BID B

Agency Name WISDOT	Solicitation Title 2020 HUMAN SERVICES VEHICLES	Solicitation Reference Number 510366
-----------------------	----------------------------------------------------	-----------------------------------------

QUESTIONS AND ANSWERS FOR SOLICITATION NUMBER 510366
2020 HUMAN SERVICE VEHICLES – MEDIUM BUSES AND REAR LOAD WAGON/VAN
ROUND ONE – JULY 24TH, 2020

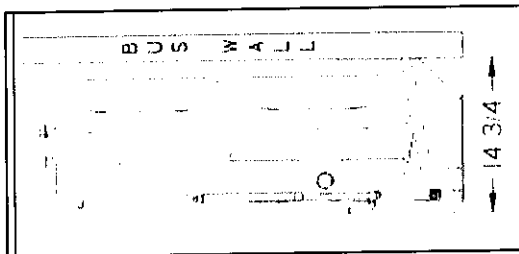
11.4 – Driver Running Board - Expanded metal stainless steel running board with 11 gauge expanded metal step tread, 16 gauge framing on driver's side, Maximum ground-to-step height of 12" and a minimum tread depth of 8", Must extend 6" maximum outward from driver door threshold - Please allow for a diamond plate running board in lieu of expanded metal. Also please remove outward threshold maximum and change to minimum as it contradicts the minimum tread depth of 8". Our step has a nice large tread depth of 12" and would extend past the 6" maximum outward from threshold. – Approved. Running board must be coated or protected to combat rust and corrosion.

Please accept the current honeycomb bus WISDOT approved stainless steel driver side running board. - Vendor needs to include a specific verbiage to be approved equal. Please don't reference previous solicitations or addendums that may not be available for everyone to view. If the substitute running board meets the current specifications or approved equals in this addendum, that is allowed.

Please accept a diamond plate running board for the honeycomb bus. – Approved. Running board must be coated or protected to combat rust and corrosion.

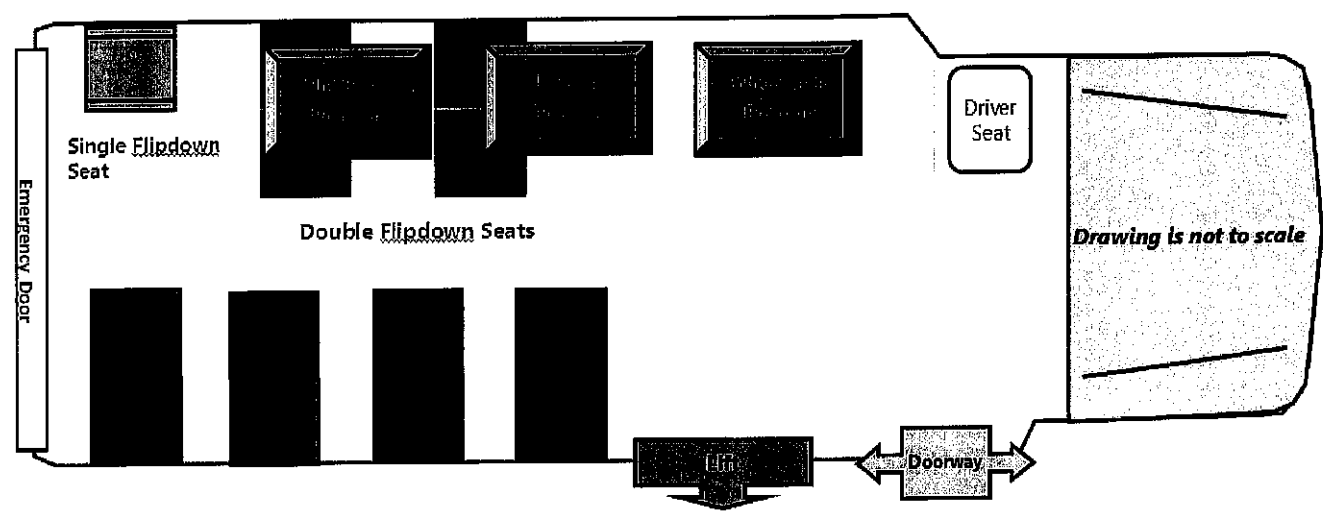
21.2 - Lift Doorway - Shall have a minimum 56-inch door height. We believe that the 56" door height does not meet ADA requirements. We believe for this class of vehicle that the ADA height needs to be 68" minimum. Please clarify. – From PART 38—AMERICANS WITH DISABILITIES ACT (ADA) ACCESSIBILITY SPECIFICATIONS FOR TRANSPORTATION VEHICLES:

Please accept the option of a double wheelchair door to insure no obstruction with the front entrance and meeting the minimum 90 degree opening. – Approved

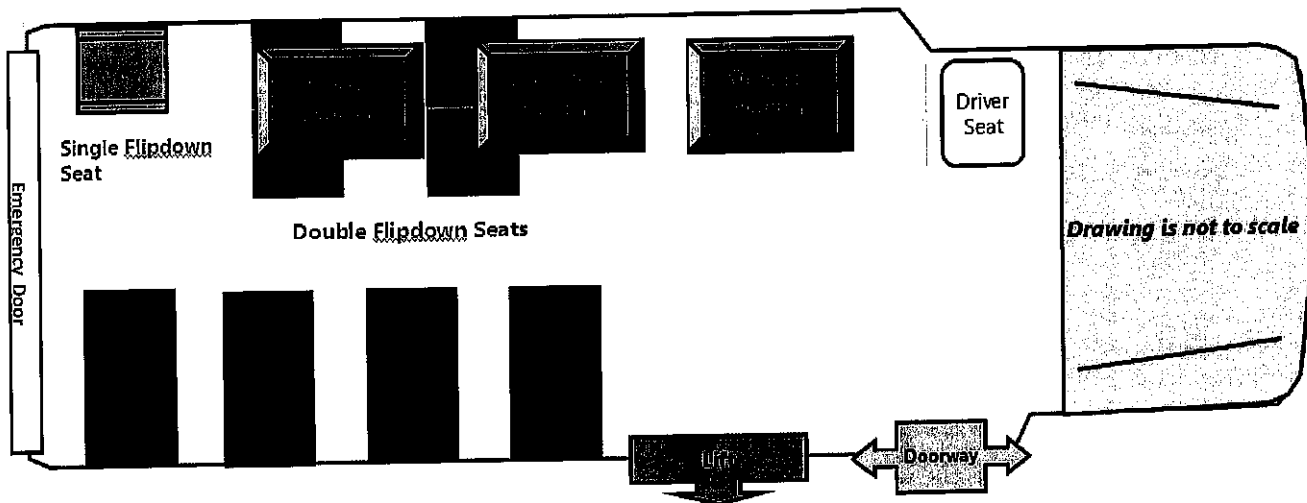
21.2 - Lift Doorway - Shall have a minimum 56-inch door height. We believe that the 56" door height does not meet ADA requirements. We believe for this class of vehicle that the ADA height needs to be 68" minimum. Please clarify. - From PART 38—AMERICANS WITH DISABILITIES ACT (ADA) ACCESSIBILITY SPECIFICATIONS FOR TRANSPORTATION VEHICLES:

Depending on the length of vehicle submitted, if it is under 22ft, 56-inch door opening is approved. If the vehicle is over 22ft, a 68-inch doorway is approved.

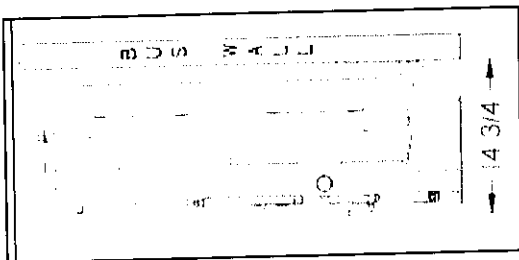
11.4 – Driver Running Board - Expanded metal stainless steel running board with 11 gauge expanded metal step tread, 16 gauge framing on driver's side, Maximum ground-to-step height of 12” and a minimum tread depth of 8”, Must extend 6” maximum outward from driver door threshold - Please allow for a diamond plate running board in lieu of expanded metal. Also please remove outward threshold maximum and change to minimum as it contradicts the minimum tread depth of 8”. Our step has a nice large tread depth of 12” and would extend past the 6” maximum outward from threshold. – Approved. Running board must be coated or protected to combat rust and corrosion.

Please accept the current honeycomb bus WISDOT approved stainless steel driver side running board. Vendor needs to include a specific verbiage to be approved equal. Please don't reference previous solicitations or addendums that may not be available for everyone to view. If the substitute running board meets the current specifications or approved equals in this addendum, that it is allowed.

Please accept a diamond plate running board for the honeycomb bus. – Approved. Running board must be coated or protected to combat rust and corrosion.
